ADDENDUM

ADDENDUM NO.: 03
PROJECT NAME: CDOT – Lincoln Square Brown Line Area Improvements
PROJECT NO.: 22705
CONTRACT NO.: C1612
DATE OF ISSUE: August 15, 2024

NOTICE OF CHANGES, MODIFICATIONS, OR CLARIFICATIONS TO CONTRACT DOCUMENTS

DRAWING NO.
SF-1
SHEET NO.
120

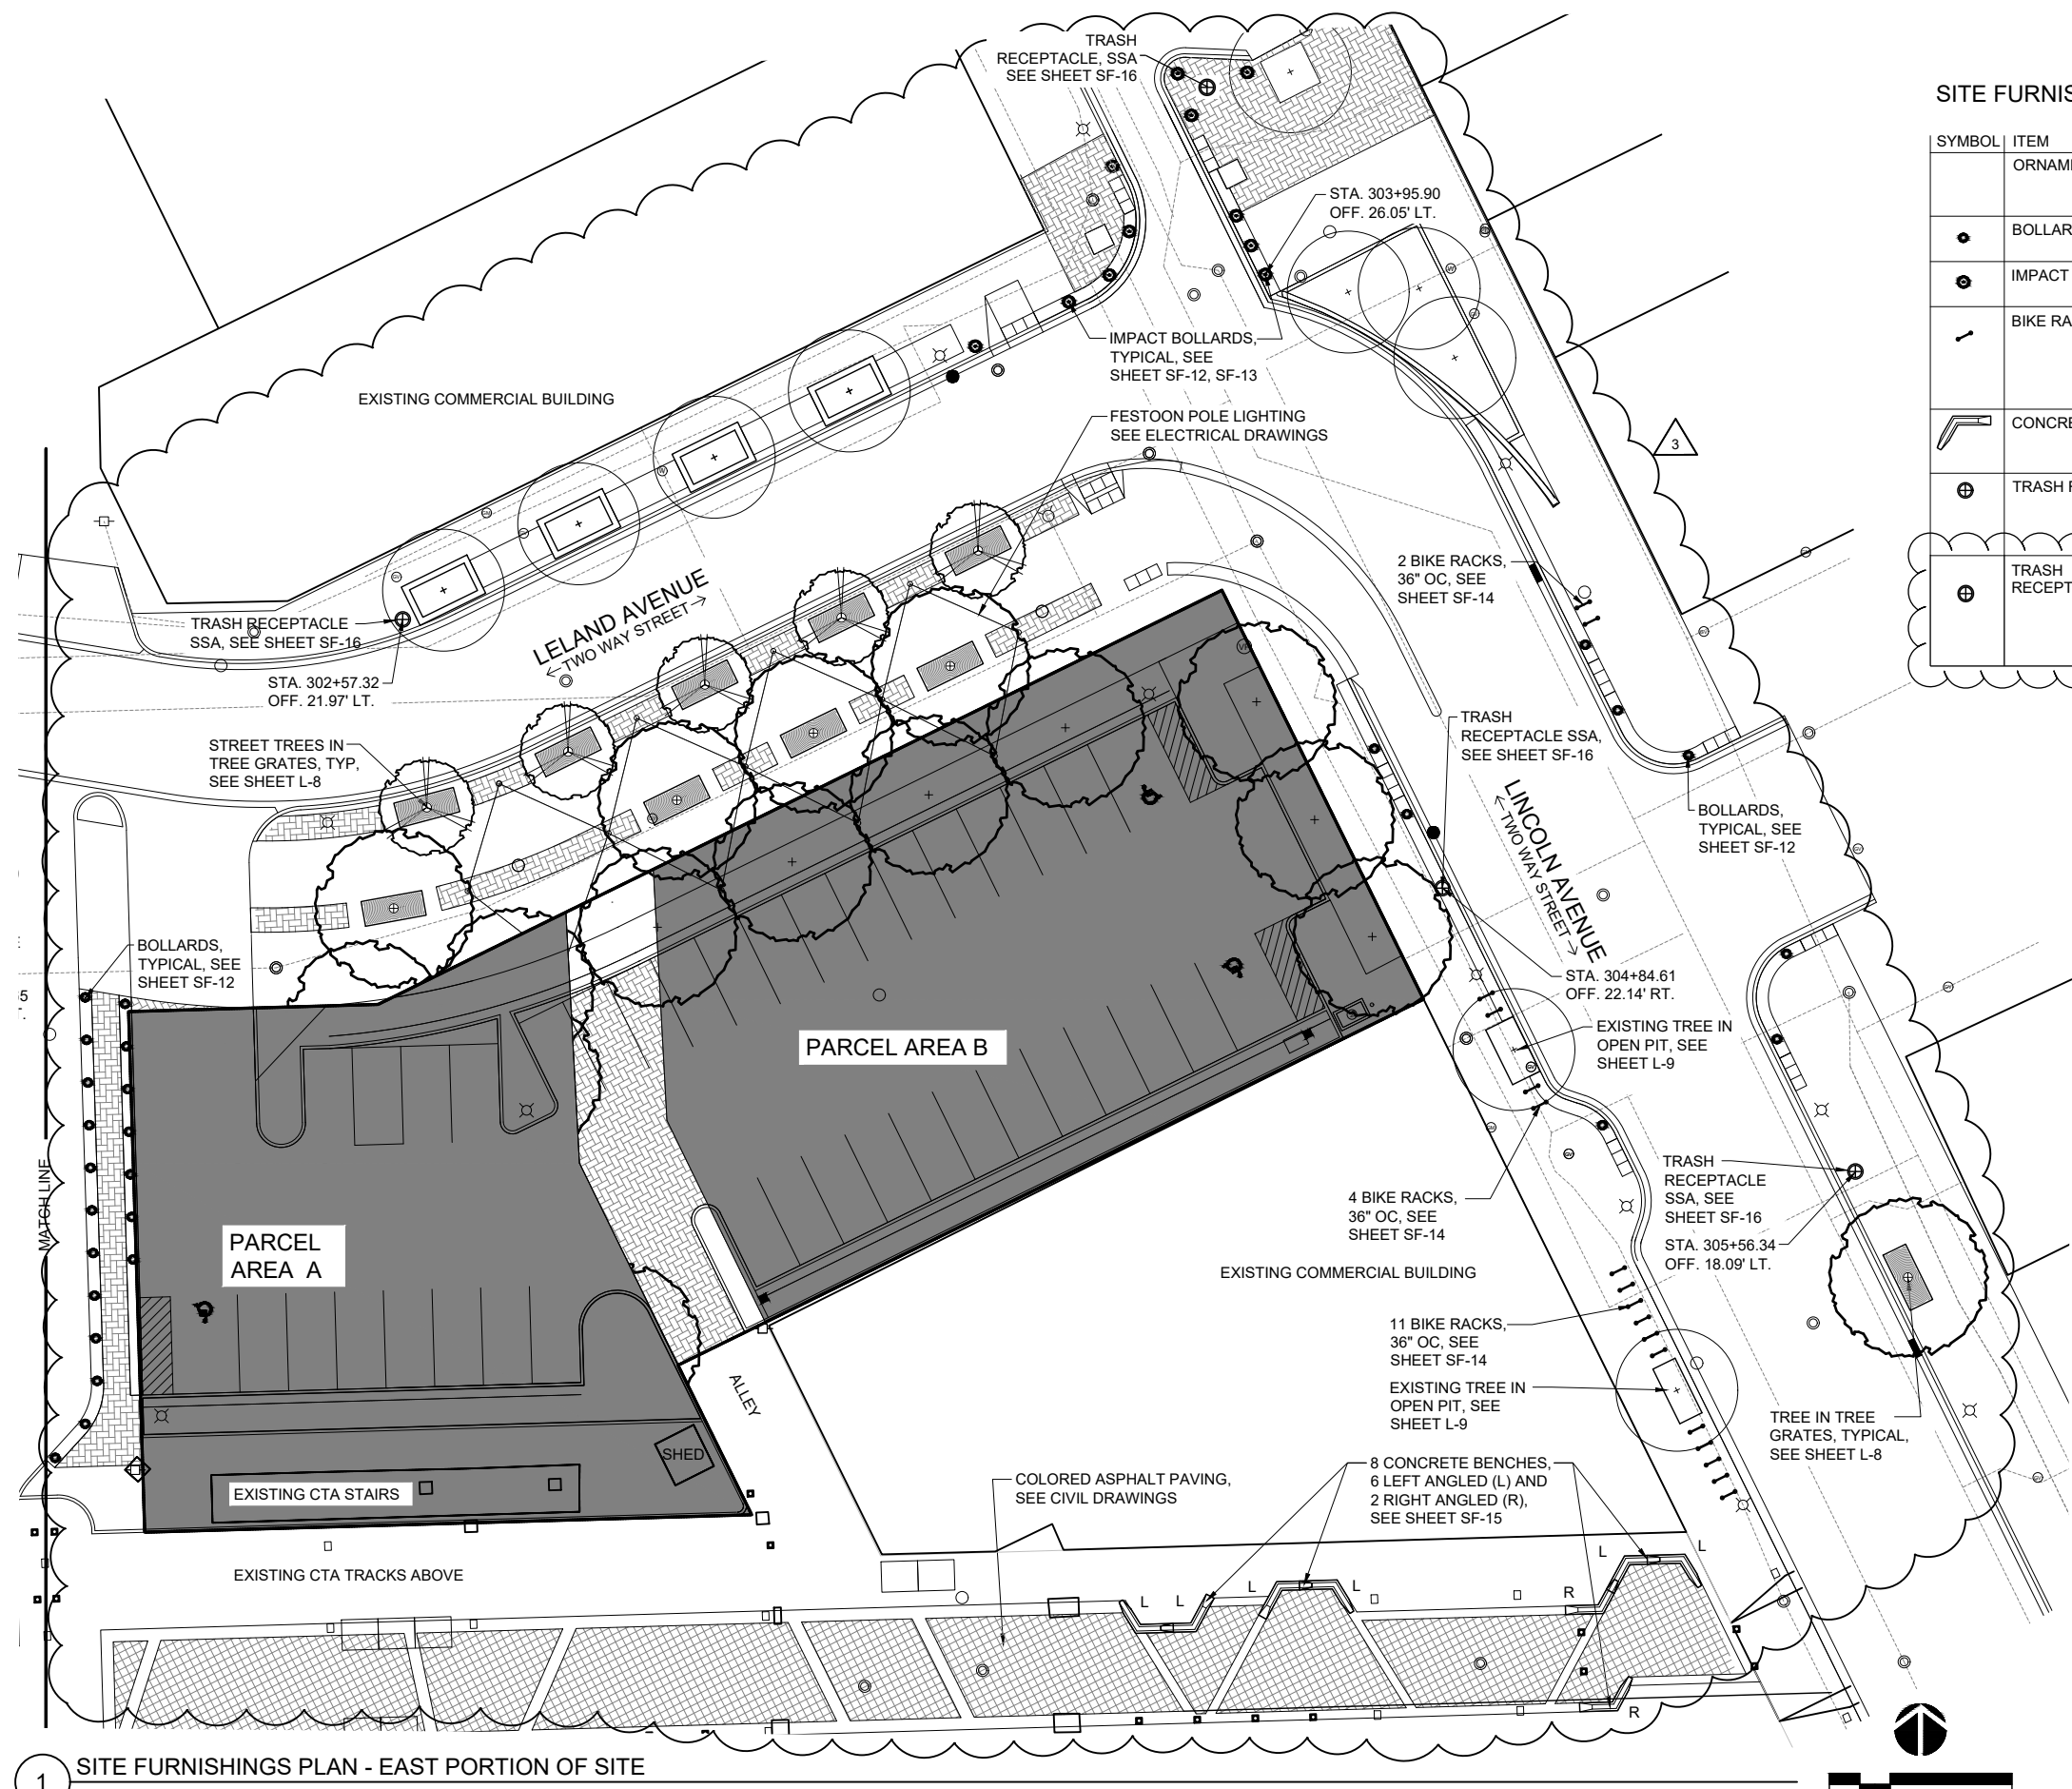
Question: Refer to sheet S00-3. The schedule of quantities shows that there are (3 EA) of Item No. 208 "TRASH RECEPTACLES." Refer to Sheet SF-1 and SF-2. There are (6 EA) "Litter Receptacles" shown, detailed on sheet SF-16. Please revise the schedule of quantities to reflect the quantities shown in the contract drawings, or indicate if any of the "Litter Receptacles" shown should be counted as "TRASH RECEPTACLES, SSA" (referring to RFI 1).

Response: [Drawing SF-1 and Drawing SF-2 have been revised and are included in this addendum. The schedule of quantities and callouts on each sheet clarify what trash receptacle type is specified at each location. The quantities as listed in the Master Bid Form - Schedule of Prices remain unchanged.](#)

DRAWING NO. **SF-5**
SHEET NO. 124

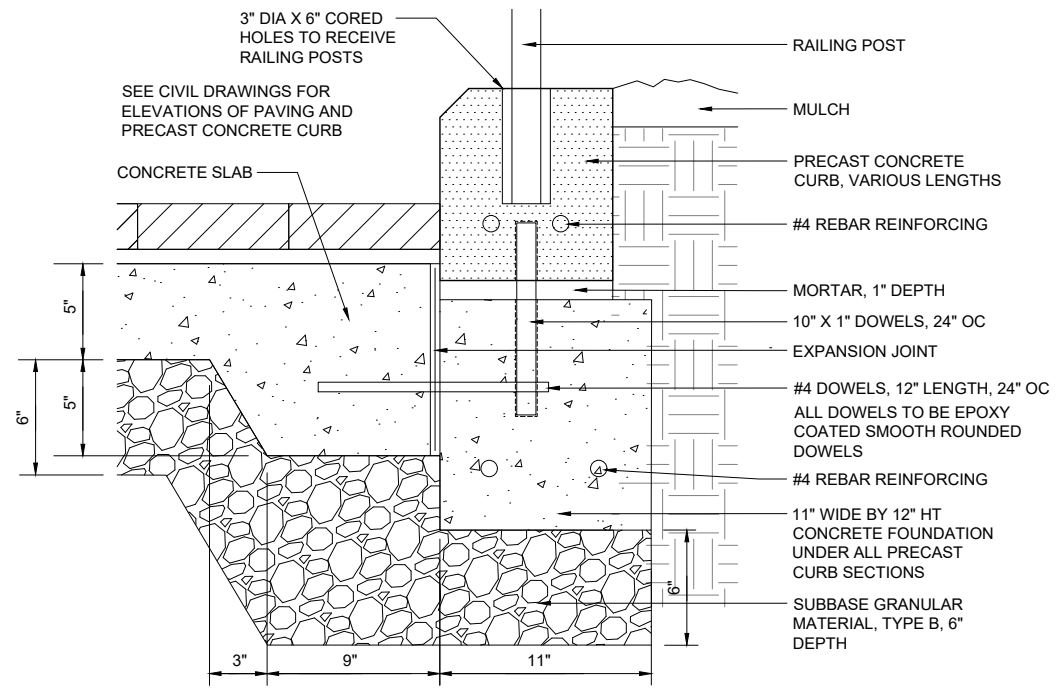
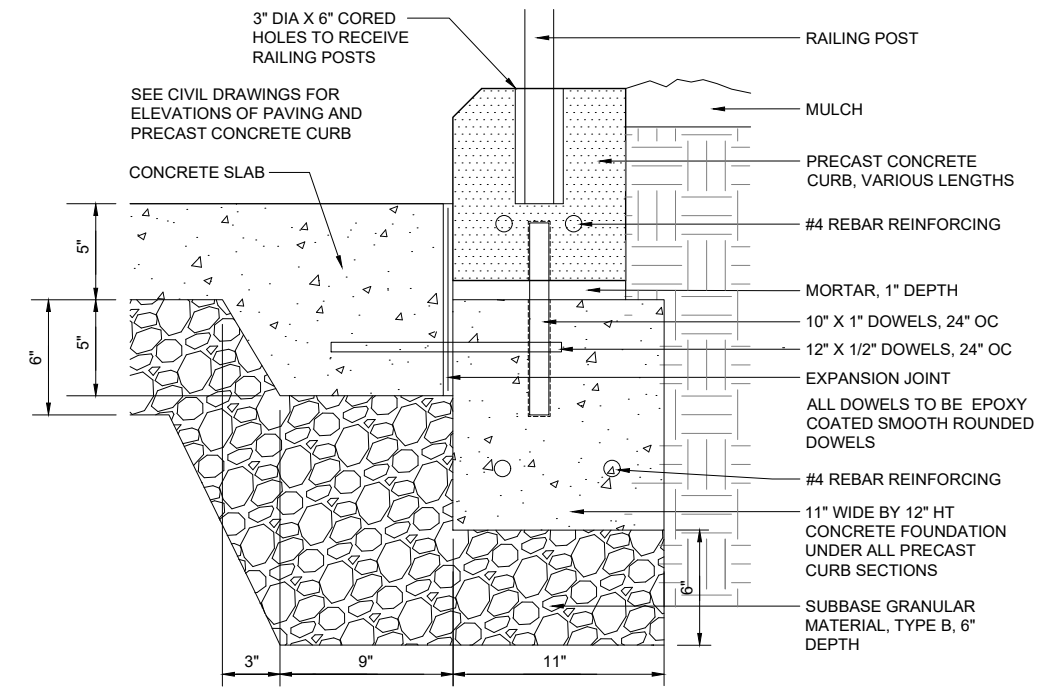
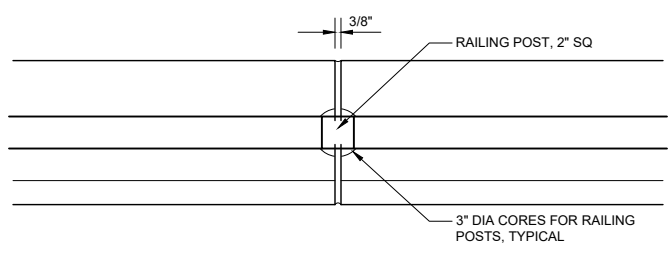
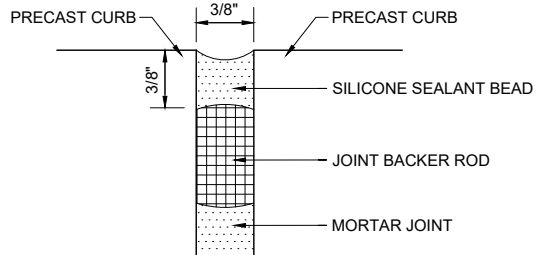
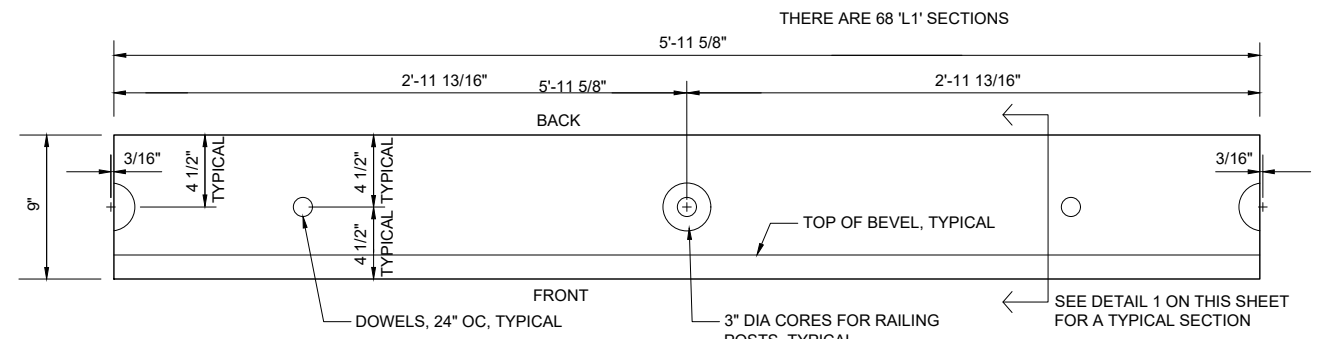
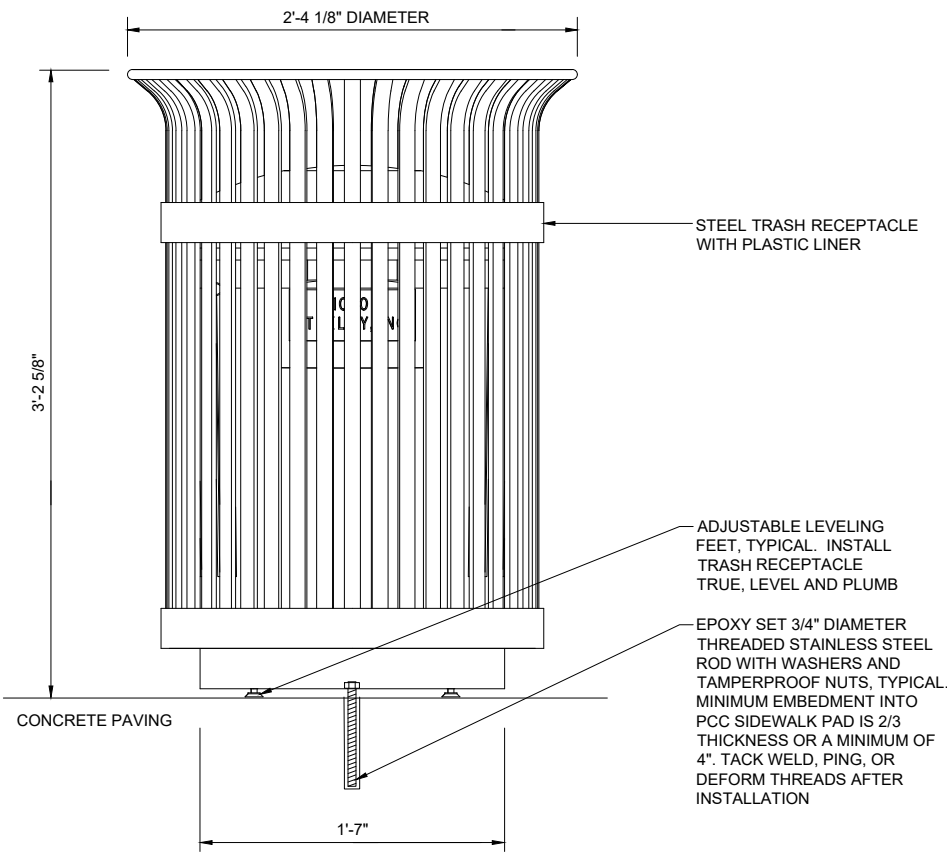
Question: Reference the SIDE VIEW detail on sheet SF-5. Detail states "PRECAST CURB COLOR AND FINISH TO BE DETERMINED BY CDOT." It is assumed that the precast curb will be standard architectural precast with acid wash finish. If this is not the case, please provide a color and finish for bidding purposes.

Response: [The precast curb color and finish is to be ACS Mix 2796, Job 3503. Drawing SF-5 has been revised and is included in this addendum.](#)

2 TRASH RECEPTACLE SSA DETAIL
1/2" = 1'-0"

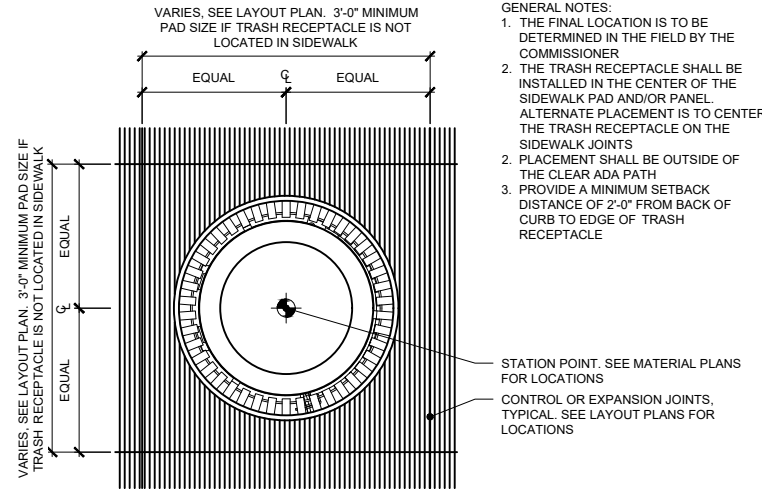
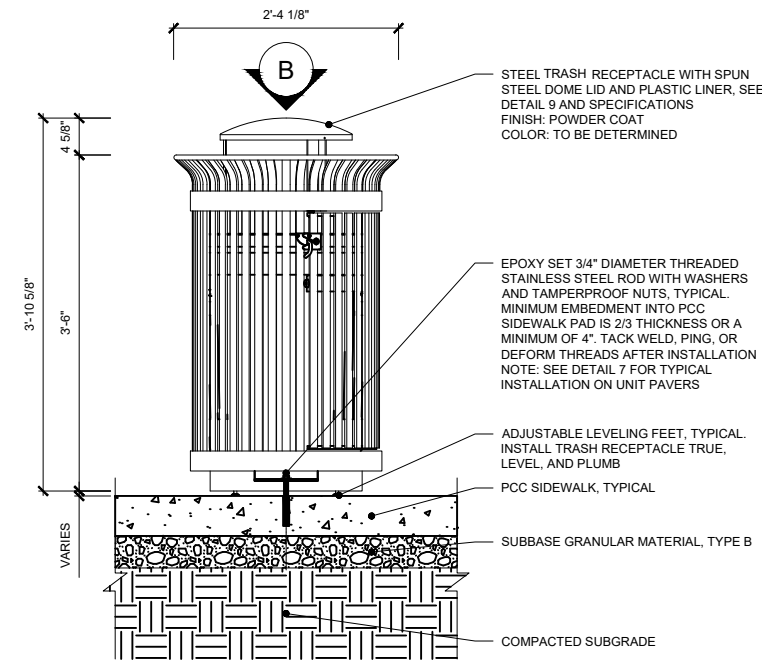
Question: Refer to sheet S00-3. The schedule of quantities shows that there are (5 EA) of Item No. 209 "TRASH RECEPTACLES, SSA." These are not shown in the contract drawings, nor is a detail provided. Please indicate the page where "TRASH RECEPTACLES, SSA" are shown on the contract drawings or revise the summary of quantities to remove Item No. 209 "TRASH RECEPTACLES, SSA."

Response: [Detail 2 for Item 209 "TRASH RECEPTACLES, SSA" has been added to Drawing No. SF-16 which has been revised and included in this addendum.](#)

DRAWING NO.
SF-20
 SHEET NO.
 139

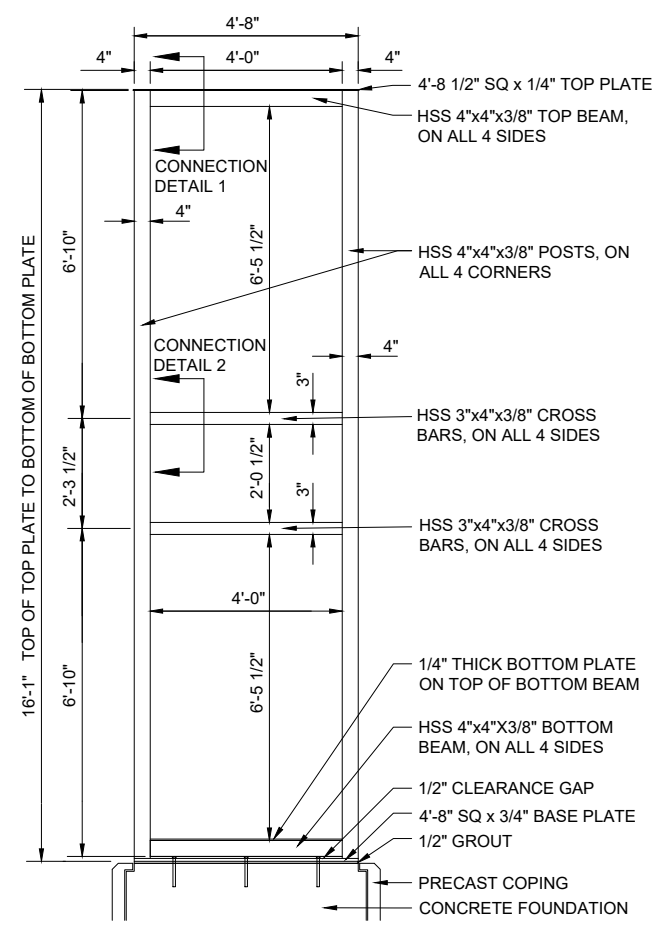
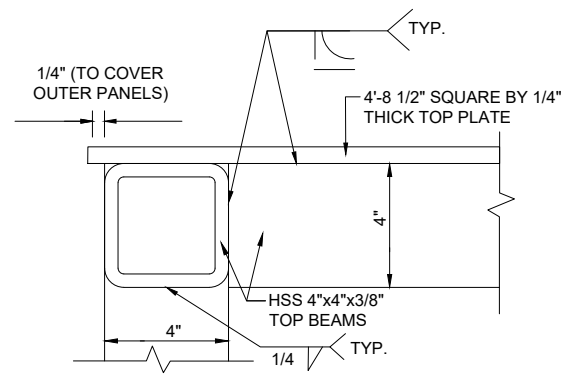
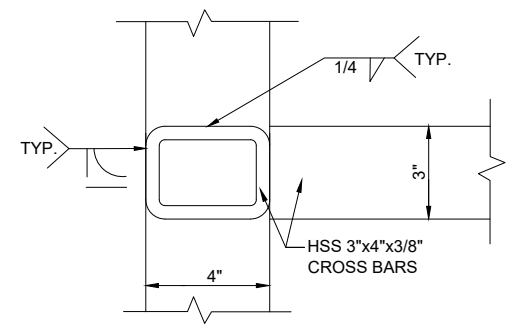
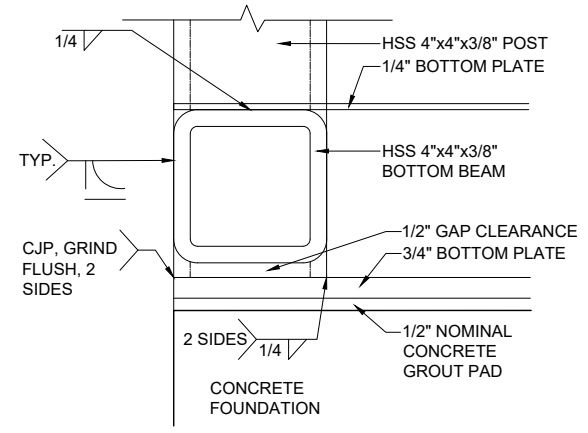
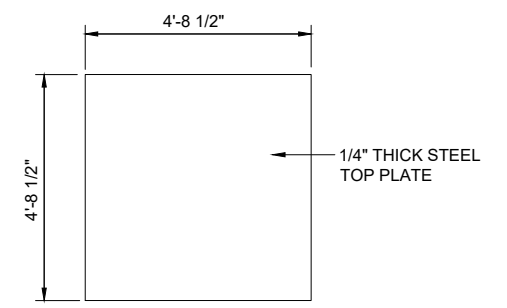
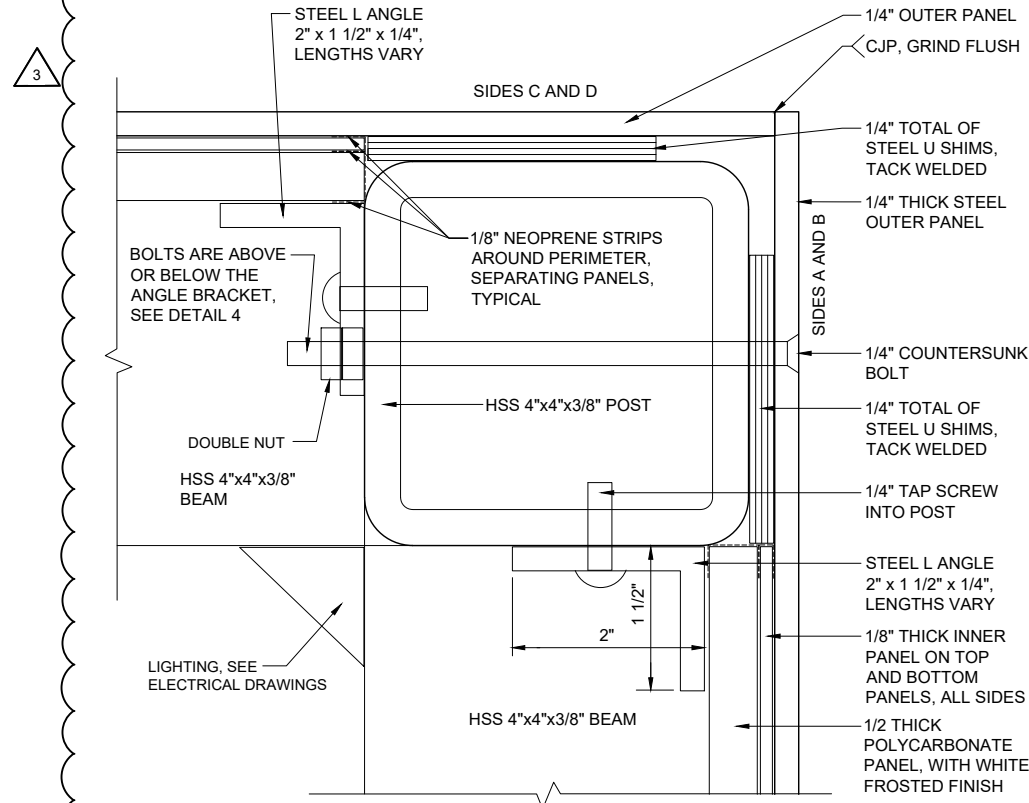
Change 12 **REVISED** Drawing No. SF-1, revisions to trash receptacles and schedule of quantities
Change 13 **REVISED** Drawing No. SF-2, revisions to trash receptacles and schedule of quantities, revisions to bollards
Change 14 **REVISED** Drawing No. SF-3, revisions to trash receptacle call outs
Change 15 **REVISED** Drawing No. SF-5, revisions to concrete curb color and mix
Change 16 **REVISED** Drawing No. SF-16, revisions to trash receptacle to include trash receptacle, SSA
Change 17 **REVISED** Drawing No. SF-17, revisions to the identifier details
Change 18 **REVISED** Drawing No. SF-18, revisions to the identifier details
Change 19 **REVISED** Drawing No. SF-19, revisions to the identifier details
Change 20 **REVISED** Drawing No. SF-20, revisions to the identifier details
